Subject: P.H.O. APPLICATION NO. PHO-3-25--Z-8-22-1 – Notice of Pending Actions by the Planning Hearing Officer

APPLICATION NO: PHO-3-25--Z-8-22-1

Request For: Stipulation Modification

Re: Stipulation Modification – Z-8-22 – SEC of Jenny Lin Road and I-17 frontage road

See "Sidewalk Shading Exhibit" for locations of each achievable shading % for sidewalks and trails.

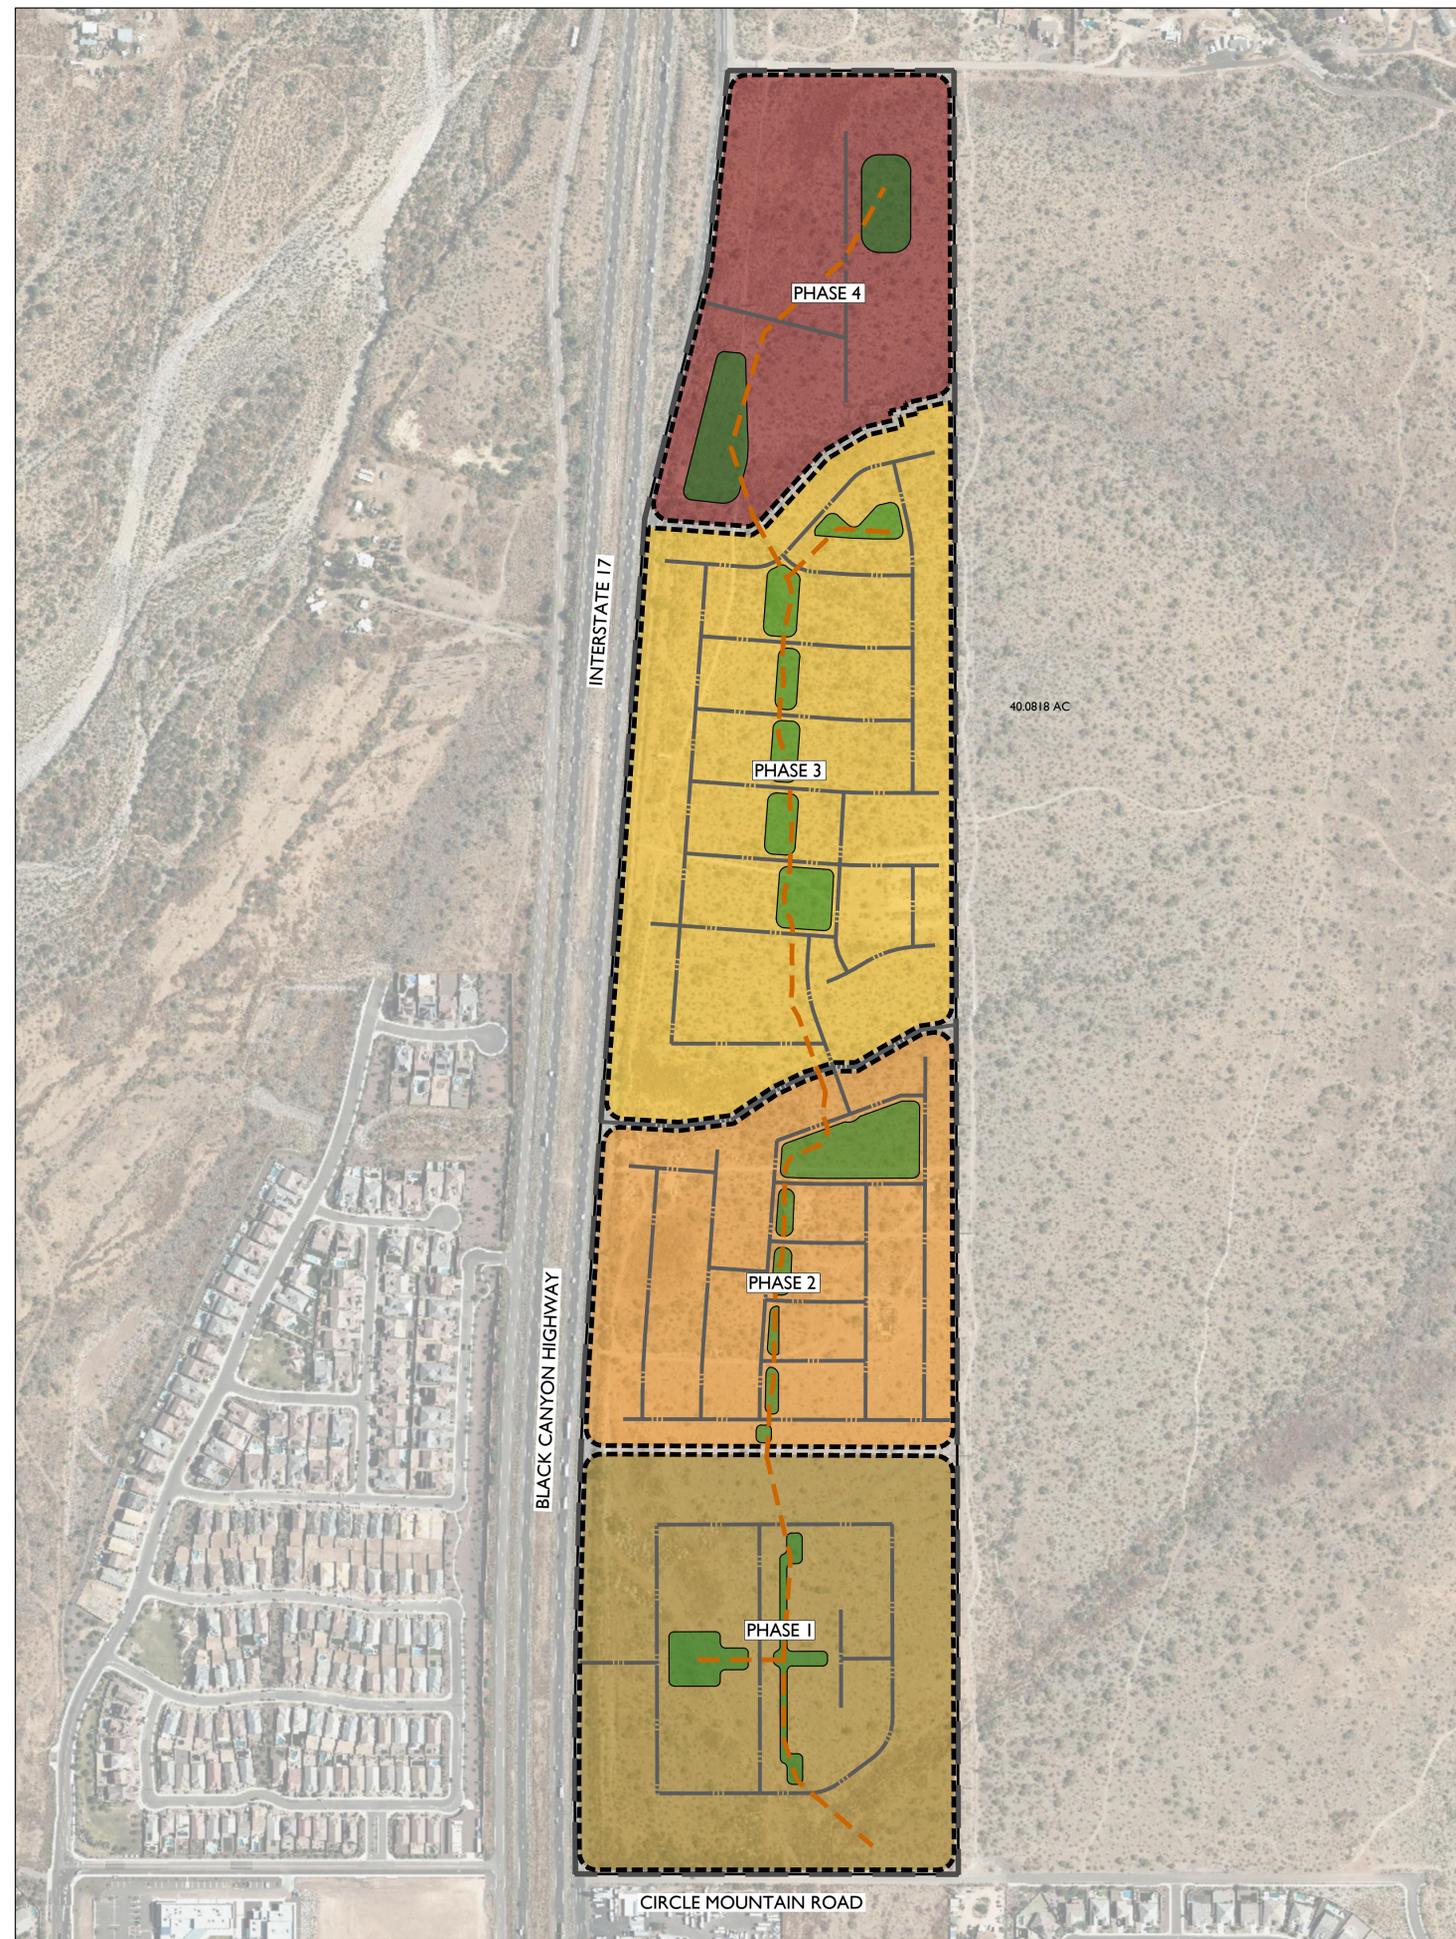
6. All pedestrian pathways and trails, including sidewalks, shall be shaded by a structure, landscaping at maturity, or a combination of the two to provide minimum ~~75~~ 53% shade, calculated at summer solstice at noon as shown on a shading study, as approved by the Planning and Development Department.

Rationale: Based on our shade study and exhibits that was submitted with the PHO application, we are able to provide 53% of shade on these pedestrian pathways and sidewalks.
